Noisy idler roller with short service life

This TI applies to all 4-series trucks and buses, as well as industrial and marine engines.

Idler roller with plastic cover for poly-V-belt.

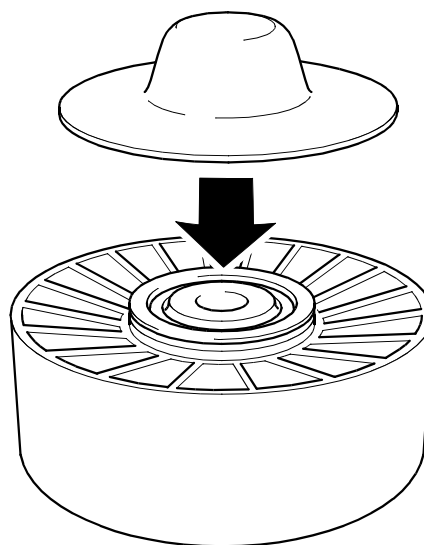
Contamination has penetrated between the dust cover and the bearing on the idler roller. This has led to noise and, in some cases, bearing failure.

A new plastic dust cover has been introduced.

If the vehicle has previously had problems with the idler roller, the metal cover on the roller should be replaced with the new plastic cover.

1. Remove the idler roller. Remove the metal cover.
2. Fit the idler roller and snap on the new plastic cover.

Note: The bearing is not symmetrical. There are grooves on one side, into which the plastic cover can be clipped. The metal protector on the other side must be left in position.
